**IN THE MATTER OF AN APPLICATION TO
AN BORD PLEANALA**

**For Approval of the Railway (Metrolink – Estuary to Charlemont via
Dublin Airport) Order [2022]**

ABP-314724-22

Schedule of Errata

CHARLEMONT TTM DRAWING

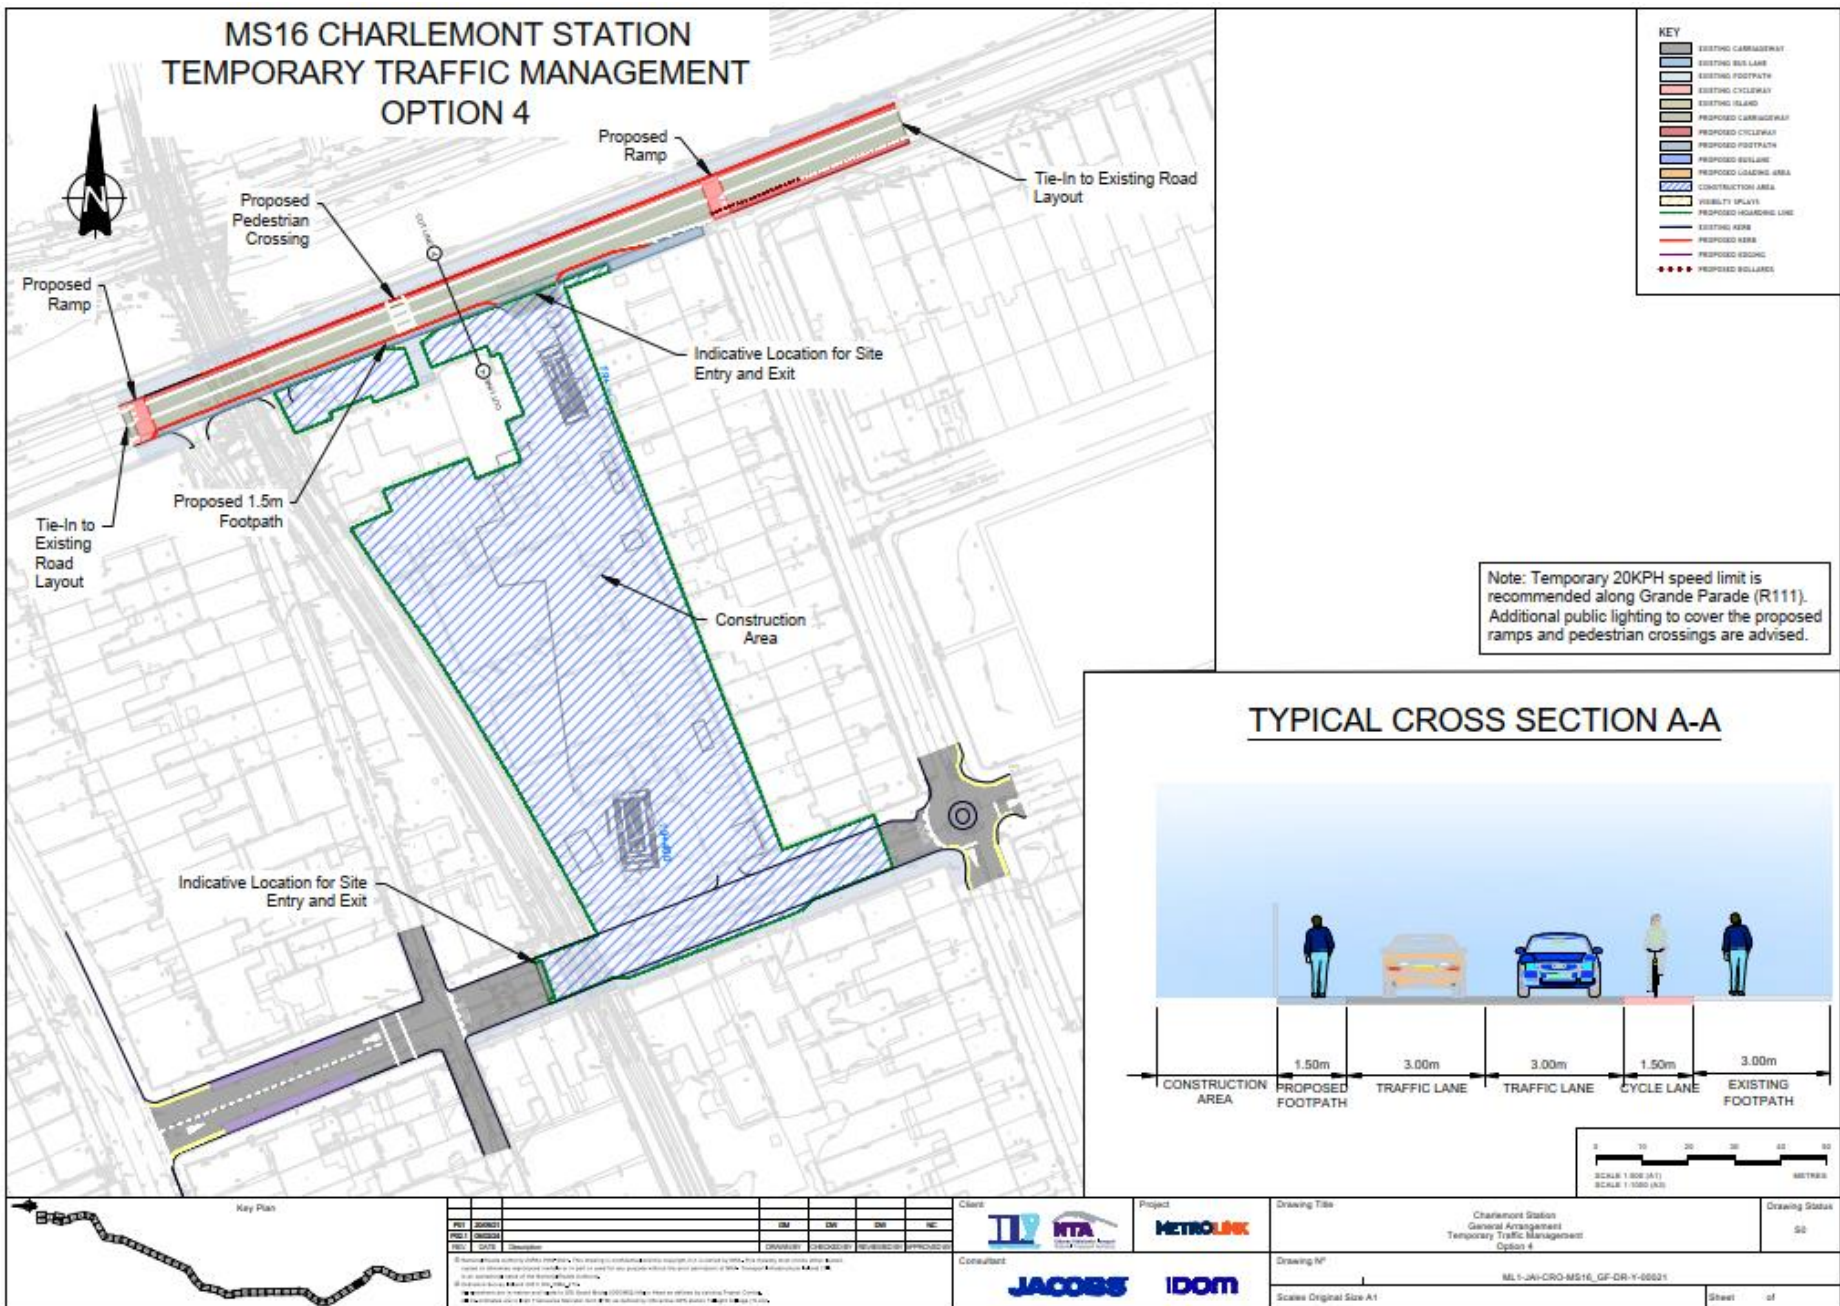
Item No.	EIAR/ NIS/ RO/ Other doc?	Section	Page	Error	Correction
87.	Appendix 9.5 Scheme Traffic Management Plan	Appendix B, Drawing ML1-JAI-MS16 GF-DR-Y00021	509	Hoarding shown in wrong position	Hoarding re-positioned, Please refer to drawing ML1-JAI-MS16 GF-DR-Y00021 in Appendix 7
